SUTHERLAND SHIRE COUNCIL ASSESSMENT REPORT

Panel Reference	PPSSSH-123
DA Number	DA22/0995
LGA	Sutherland Shire Council
Proposed Development	Upgrade of existing car parking and construction of a new basement car park and increase of student capacity to 970 students for Shire Christian School
Street Address	16 Allies Road, Barden Ridge, NSW, 2234
Applicant/Owner	Urbis Pty Ltd
Date of DA lodgement	25 October 2022
Number of Submissions	First public notification - 14 submissions Second notification of amended plans - 10 submissions
Recommendation	Deferred Commencement Consent
Regional Development Criteria (Schedule 6 of the SEPP (State Environmental Planning Policy (Planning Systems) 2021)	Private infrastructure or community facilities over \$5 million
List of all relevant s4.15(1)(a) matters	<ul style="list-style-type: none"> • Sutherland Shire Local Environmental Plan 2015 (SSLEP 2015). • Sutherland Shire Development Control Plan 2015 (SSDCP 2015). • State Environmental Planning Policy (Resilience and Hazards) 2021 • State Environmental Planning Policy (Transport and Infrastructure) 2021 • State Environmental Planning Policy (Biodiversity and Conservation) 2021 • State Environmental

Figure 9: Basement and watermain section showing structural details

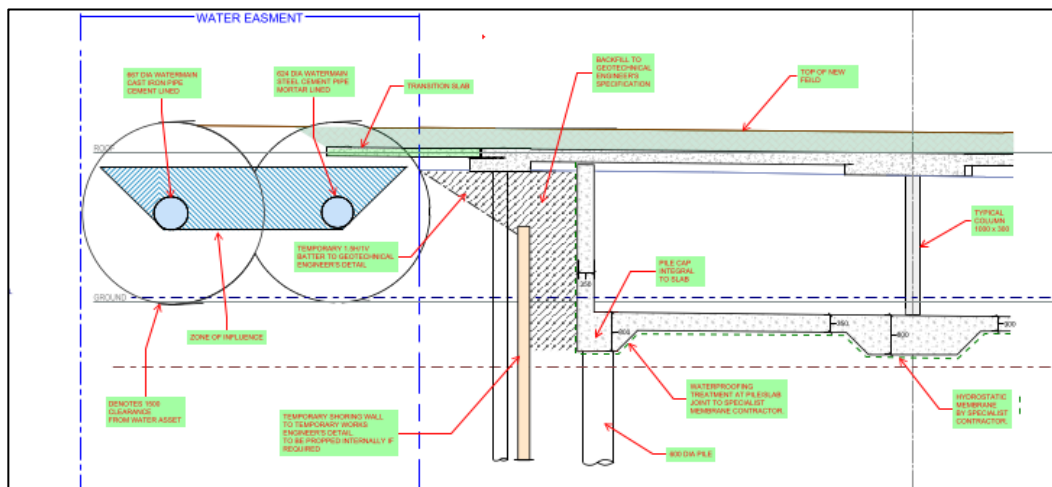
Two (2) critical Sydney Water assets identified as CICL trunk watermain are in the associated easement which traverses the site and will be partially beneath the proposed transition slab leading from the basement roof into existing ground levels surrounding the sports field (as shown below).

Council officers made early enquiries with Sydney Water in November 2022 as to the need and type of information required for referral. The applicant submitted a basic Building Plan assessment which was not sufficient in the context of the critical assets. Sydney Water requested an *Out of Scope – Building Application* to be submitted for assessment in December 2022. This request was forwarded to the applicant at that time. The applicant did not submit the necessary information until July 2023. When the information was lodged by the Water Service Co-ordinator (WSC) and the referral made via the Planning Portal, the application was 'rejected' on 14 July 2023 by Sydney Waters engineering team due to missing information / details on the plans. However, Council was advised on 17 July 2023 of acknowledgement of referral (noting it was pending), with no update on the issue until mid-September. At this time Council was advised that no further information had been submitted from the applicants WSC to resolve the rejected application.

As there has been no response or conditions offered to govern the proposed works within and adjacent to the easement area, Council officers do not recommend conditional consent for the application. Whilst all other key matters have been resolved, the options to progress the application remain limited only to a deferred commencement consent which would enable the appropriate approval and conditioning to be obtained from Sydney Water, beyond the SSPP determination time.

It is considered likely that the engineering outcomes required by Sydney Water for protection of the water asset can be reasonably resolved between the applicant (via their representing Water Services Coordinator) and Sydney Water. If the approval is not obtained within 24 months, the recommended wording of the deferred commencement conditions will result in the consent lapsing. If for some unforeseen reason, design changes are required because of this referral (which impact the basement design), the application may be modified via a s.4.55 application. Minor changes have been allowed for and detailed in the 'design changes required' condition.

Figure 11: Section from pre-DA drawing indicating sport field level up to 2m out of ground

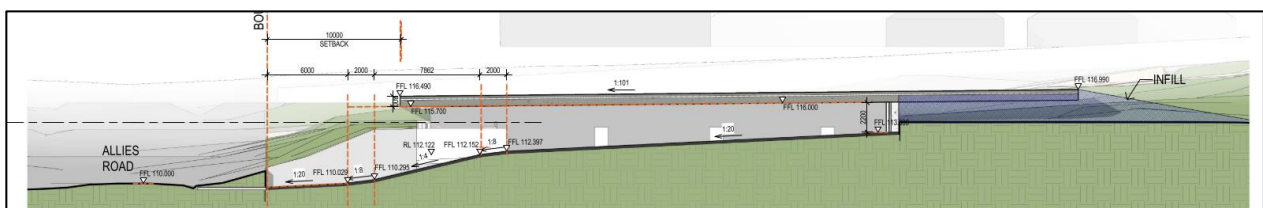
Concerns were raised regarding the potential for overlooking, noise and solar access impacts associated with the proposal. Visual impacts of privacy and overlooking were raised as a concern, specifically from the lower eastern side of the sports field (Fawkner Place). The raising of the sports playing field is the primary concern. When the applicant met with Council for Pre-DA discussions, Council raised this issue. The preliminary design sought to minimise excavation and indicated the proposed car park as higher out of the ground. In the lowest southern-eastern corner, the sport field level was proposed at RL.116.49, being nearly 2m above the existing ground level of RL.114.44 (in parts) as shown below.

In response to Council's initial amenity and streetscape concerns, the DA design has responded by setting the car parking to a typical basement configuration being generally no higher than 1m out of ground. The proposed DA design of the sports field level is much closer to existing levels where there are currently no unreasonable impacts. Adjusted levels in the south-east corner of the basement / and sports field level is now at RL.115.129. In the location centred behind the soccer goal, the proposed level is RL.115.32. The minor level difference is due to drainage fall in the roof design. These levels are taken at the eastern edge of the basement protruding above the existing ground level. The setback of the sport field roof to the eastern site boundary (shared with Fawkner Place residents) is 10m away and is best illustrated in the landscape

Figure 12: Landscape section indicating separation and landscape buffer to neighbouring properties

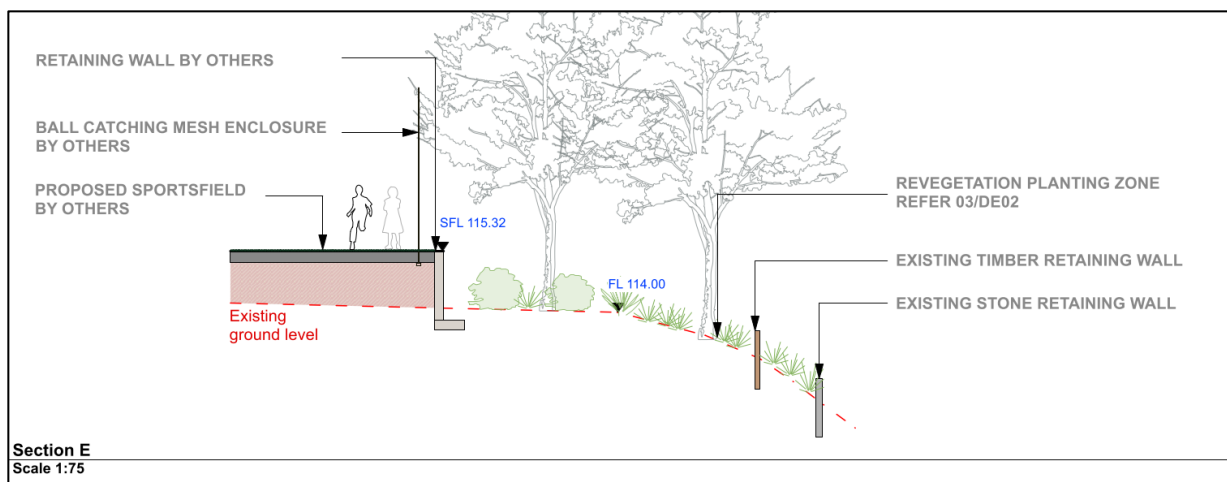
Council officers, and SSPP representatives visited the site during assessment and stood at the eastern end of the site sports field to observe the large setbacks and the area of proposed new tree planting that would result from the proposal. The inspection assisted in consideration of the potential visual and aural privacy impacts from any increase to the sports field. There were no unreasonable overlooking impacts assessed as resulting from the proposal and the mitigating factors including the large separation and landscaping serve to enable a balanced outcome between new structure/sports field and reasonable amenity preservation for adjoining neighbours.
